COA 18-71

5 Avenue A (Marina Way)

Consideration of an approval for the construction of a new restaurant.

HISTORIC PRESERVATION BOARD : PUBLIC HEARING

Building West and East Elevations

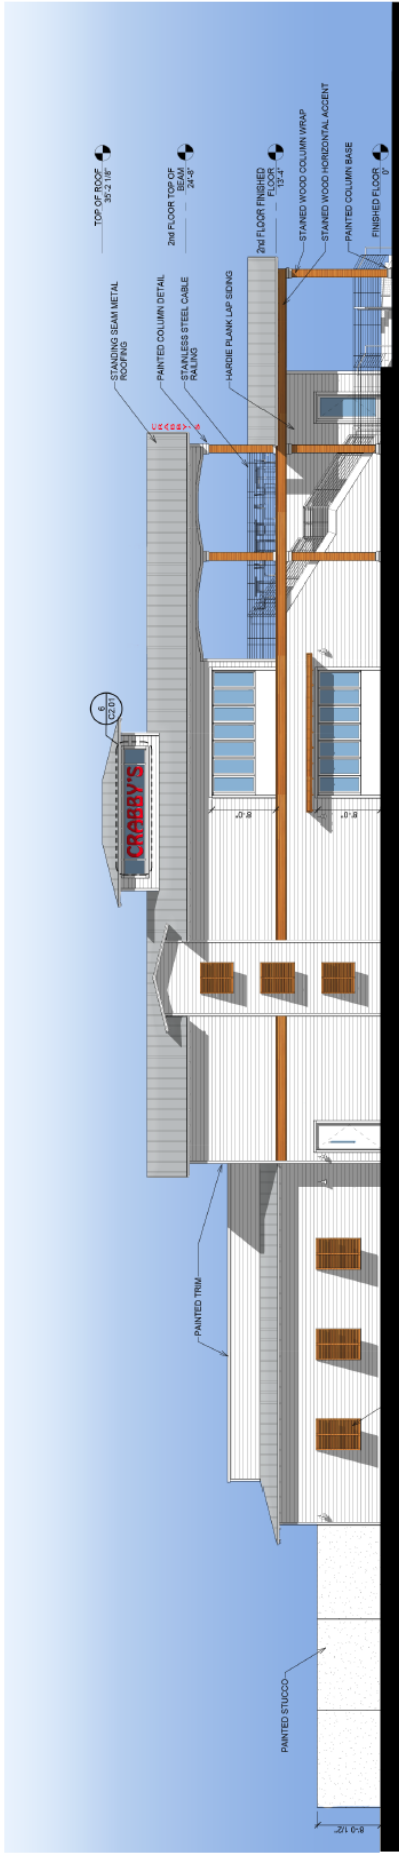
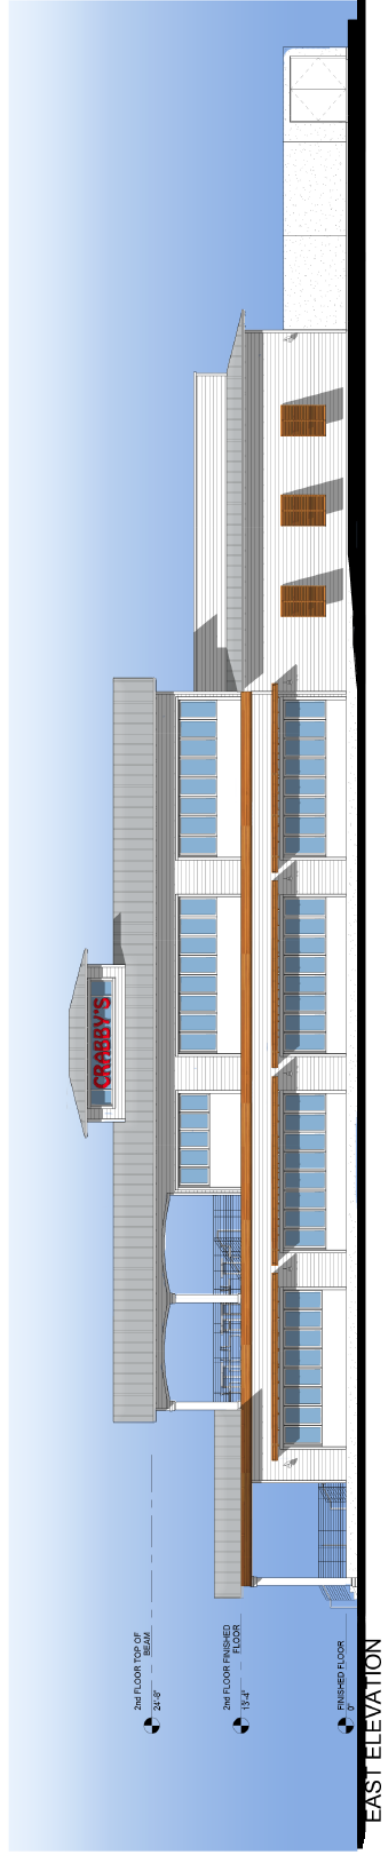
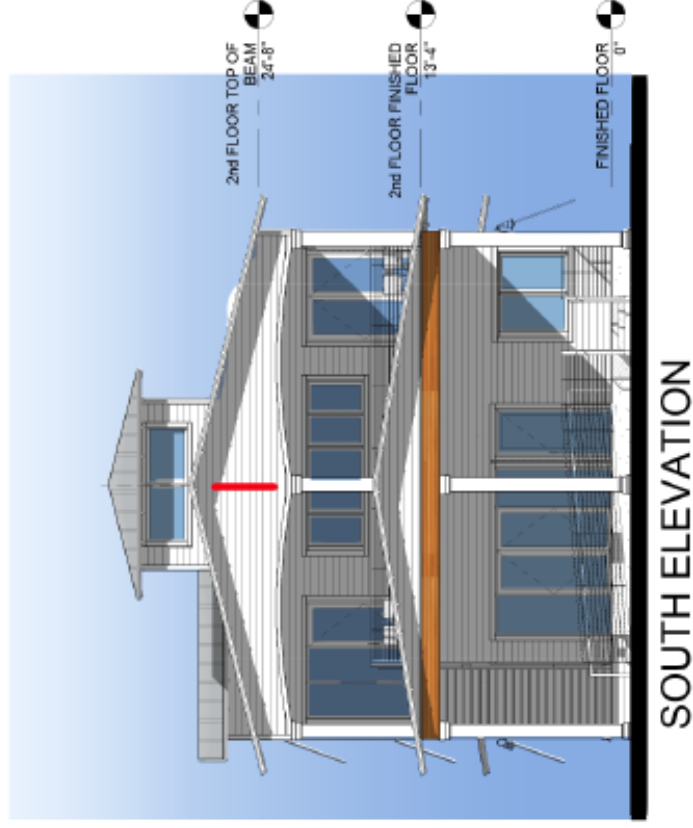
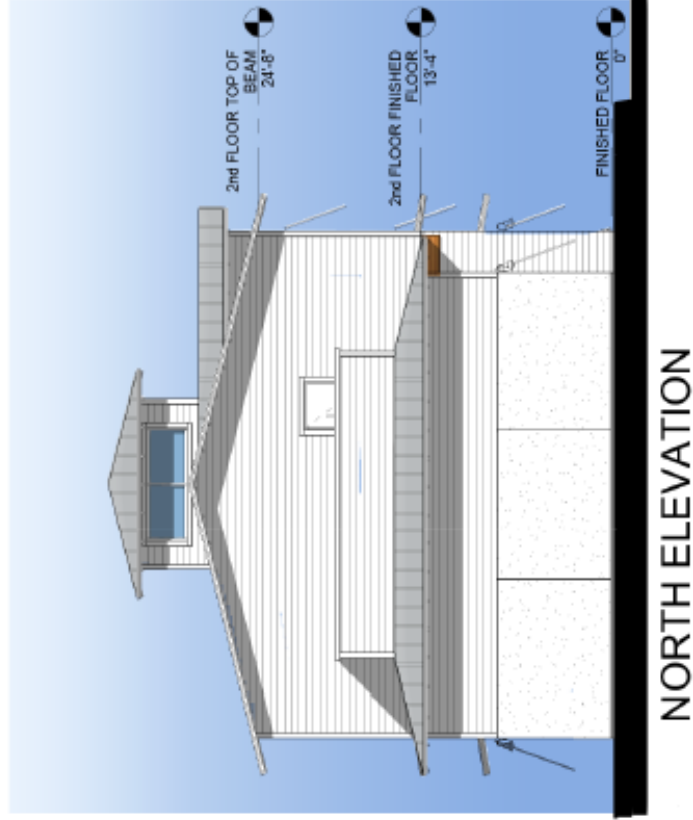
The only think which can be point out is using misplaced elements in the design of the building, like for example shutters where there is no windows. Although they break the monotony of the façade they also cause the architecture to miss its authenticity.
